ADDENDUM #1

DATE: October 6, 2011
FROM: Francisco Silva, Purchasing Agent
SUBJECT: Bid #111078 **Boundary Fencing and Fence Removal Addendum #1-**

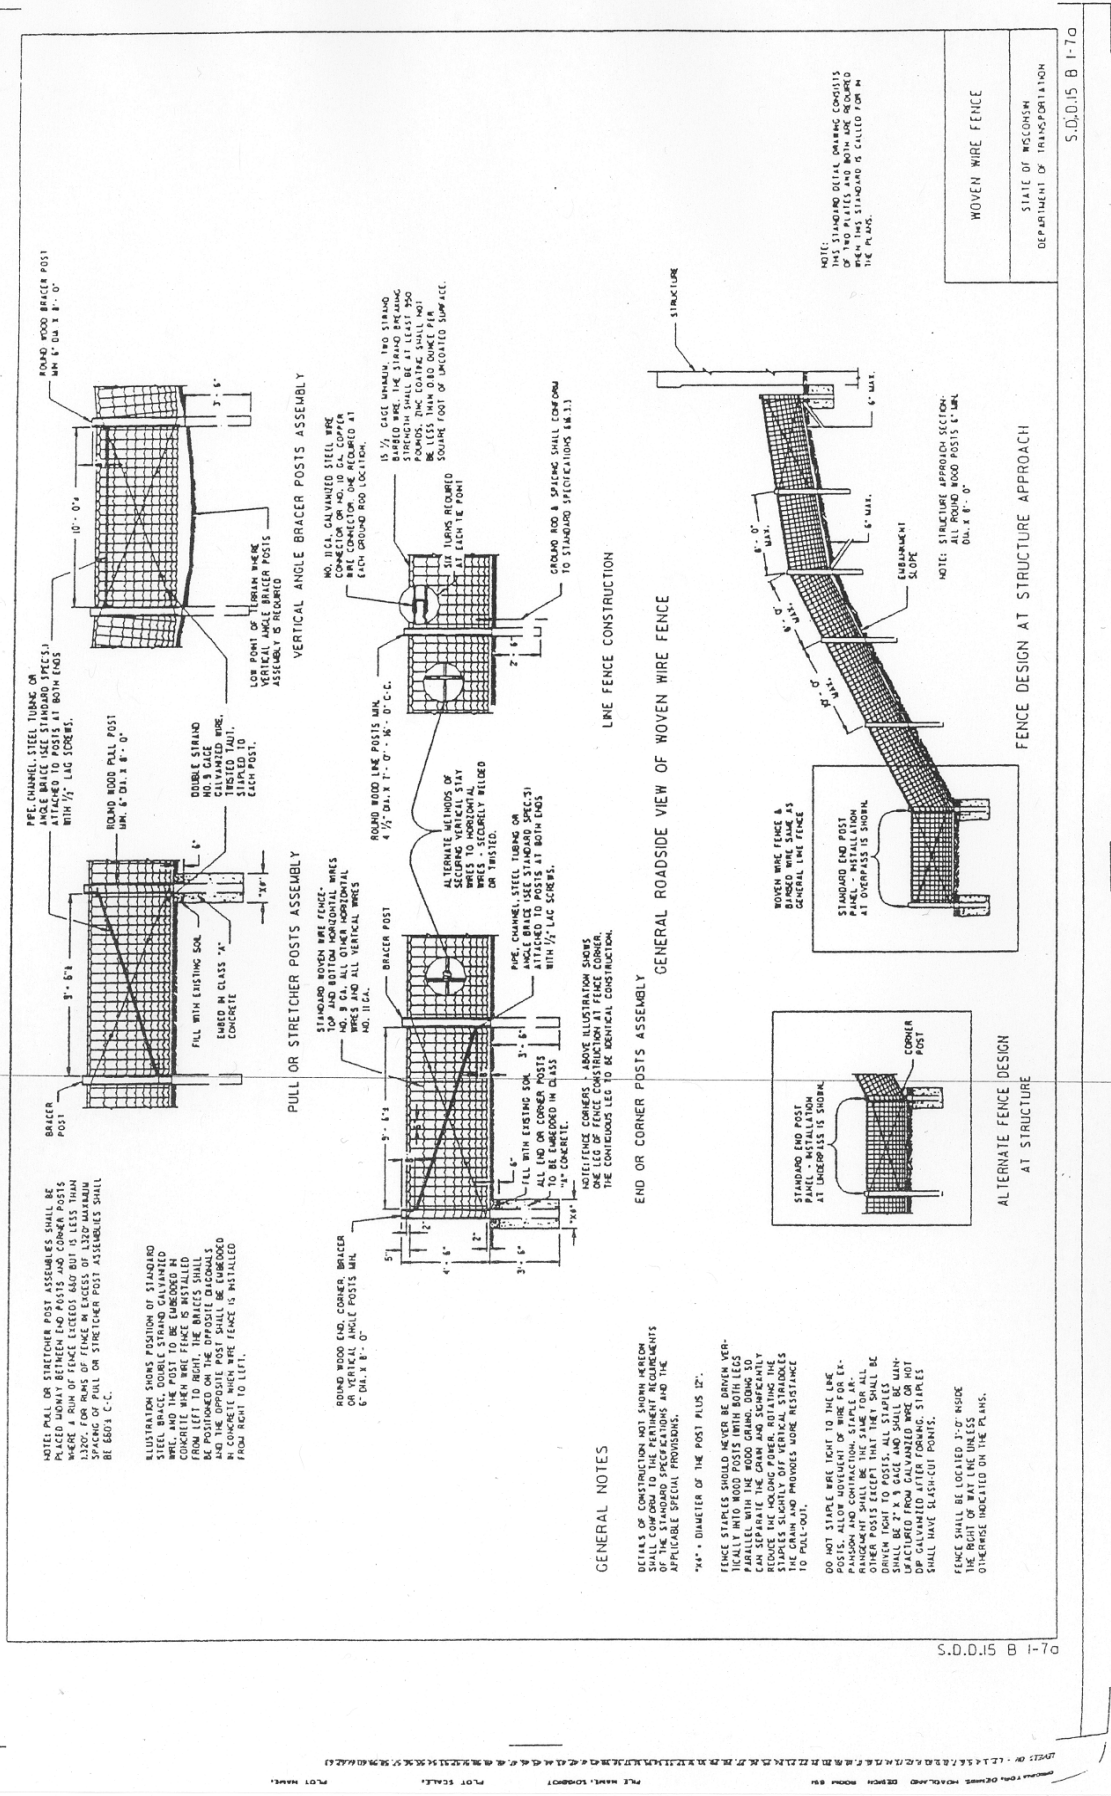
Fence Detail is similar to the Wisconsin Department of Transportation Specifications for Right of Way Fencing with Woven Wire Fence.

Exceptions

Line posts will be 6' 6" T-Posts with every fourth post being a round wood pressure treated brace post (min. 5" dia., 8' length) and will have a 10' spacing between posts.

Puller or Stretcher Posts assembly will consist of min. 6"x 6 x 10' treated posts set a min. of 5' in the ground (no concrete) and packed with ¾" gravel around posts.
